**Year 1 Monitoring Report**

**LITTLE SEBASTIAN SITE**

NCDMS Project # 100027 (Contract # 7187) | RFP 16-006993 (Issued 9/16/2016)  
USACE Action ID: SAW-2017-01507 | DWR Project # 2017-1041

RE: Little Sebastian Mitigation Site: Year 1 Monitoring Report (NCDMS Project ID #100027)

**Figure 2**

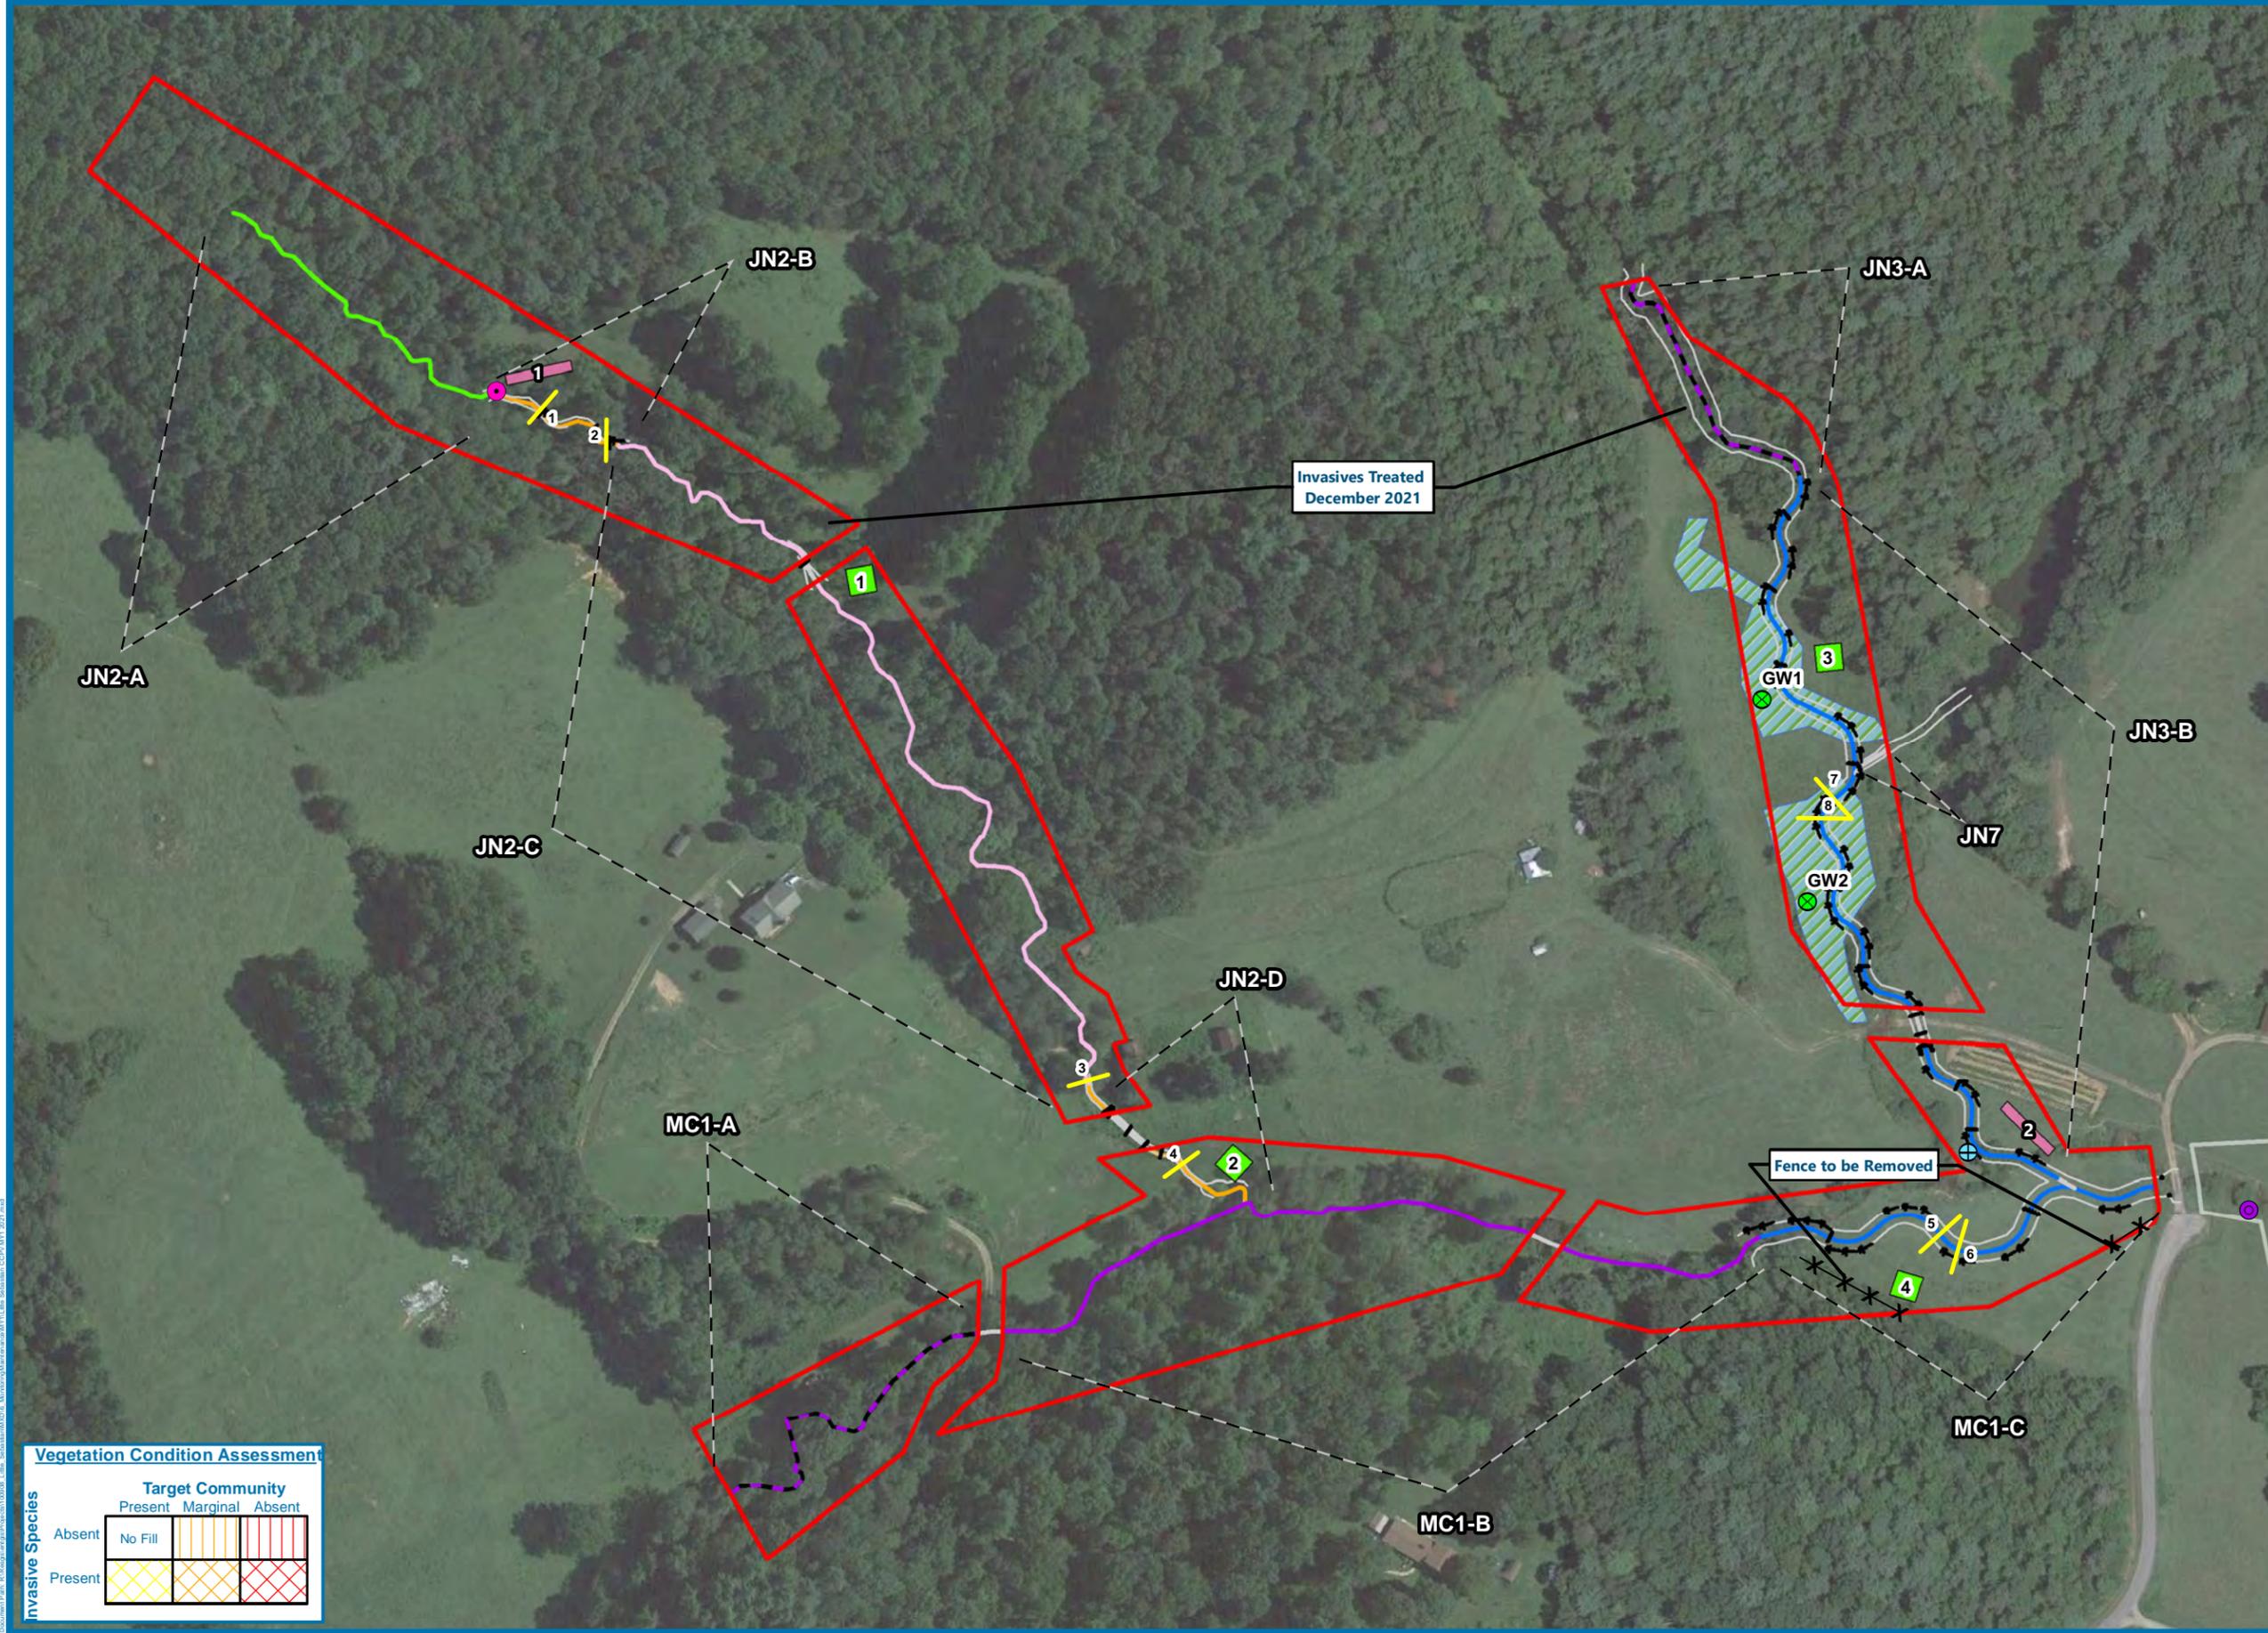
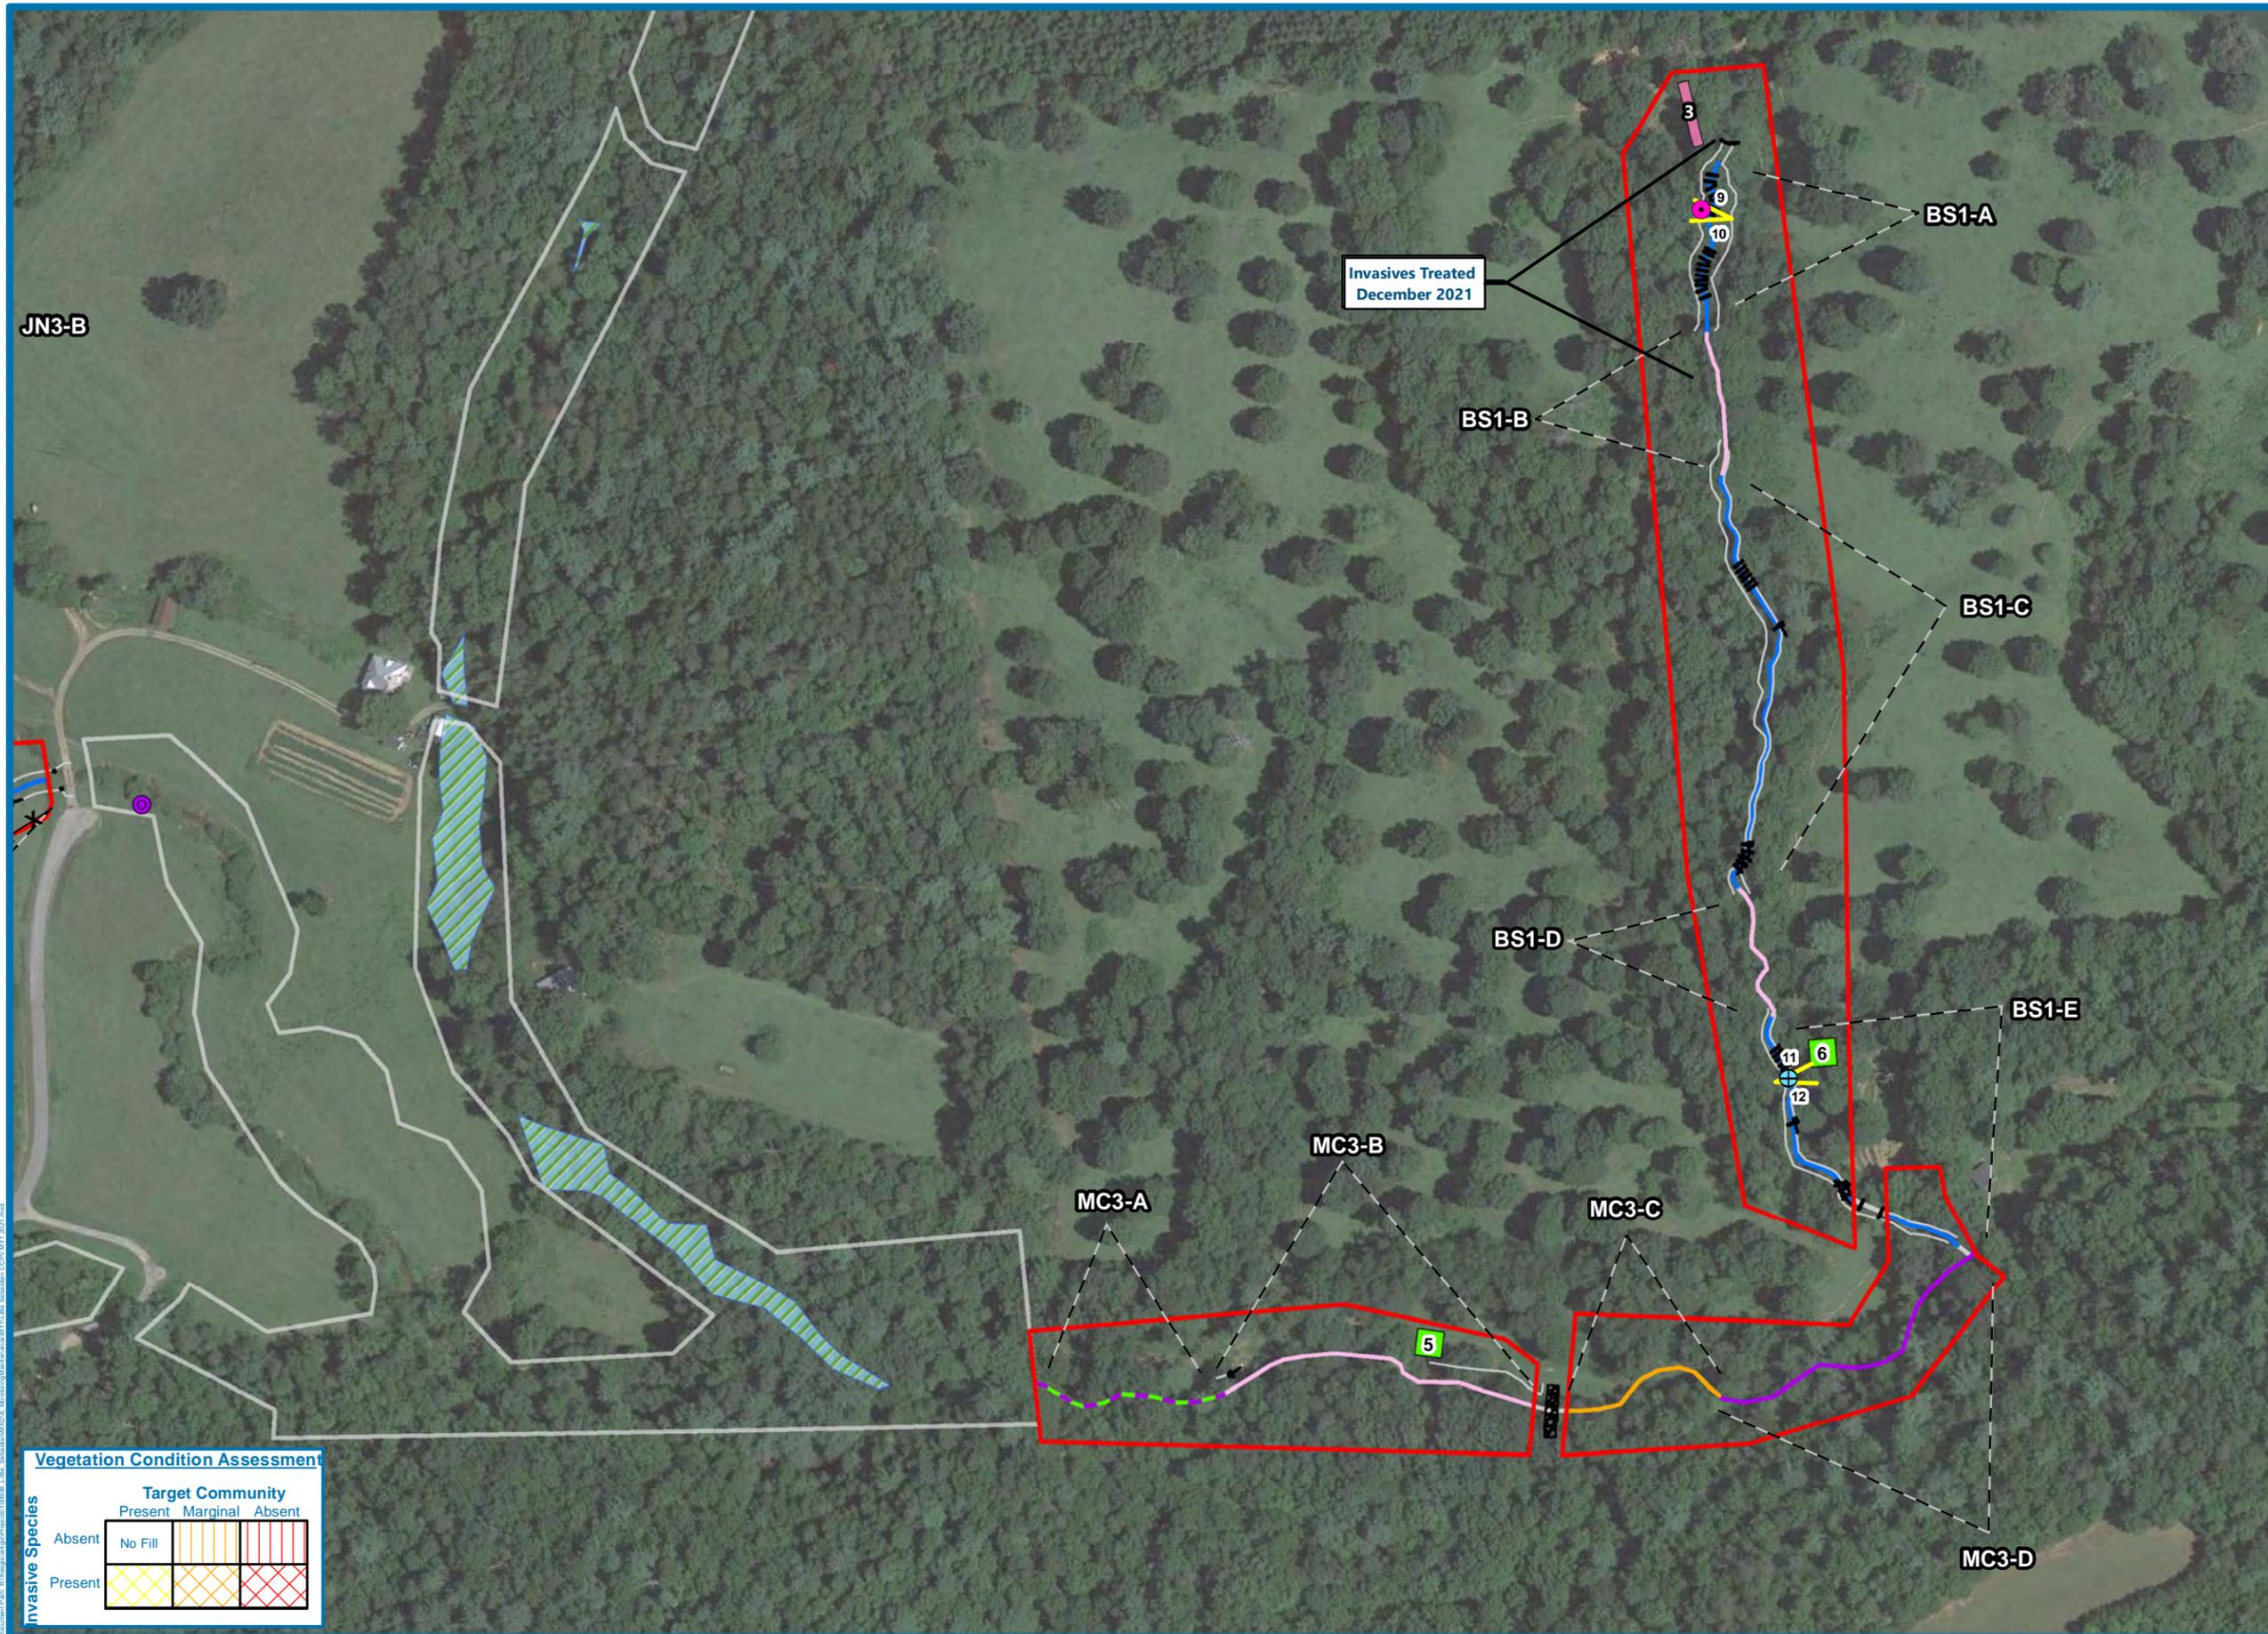
**General:** Please confirm that the two (2) areas of fencing identified within the conservation easement at MY0 (adjacent to MC1) have been relocated outside of the conservation easement or to the conservation easement line. Please point out these two relocated fence areas on the CCPV map sheets and briefly discuss in the report text.

[These areas of fencing will be relocated in early 2022. Photo documentation and a call-out on the CCPV will be provided with the 2022 MY2 report. A note has been added to Section 1.7: Monitoring Performance in the MY1 report, regarding plans to remove the fencing from within the conservation easement.](#)
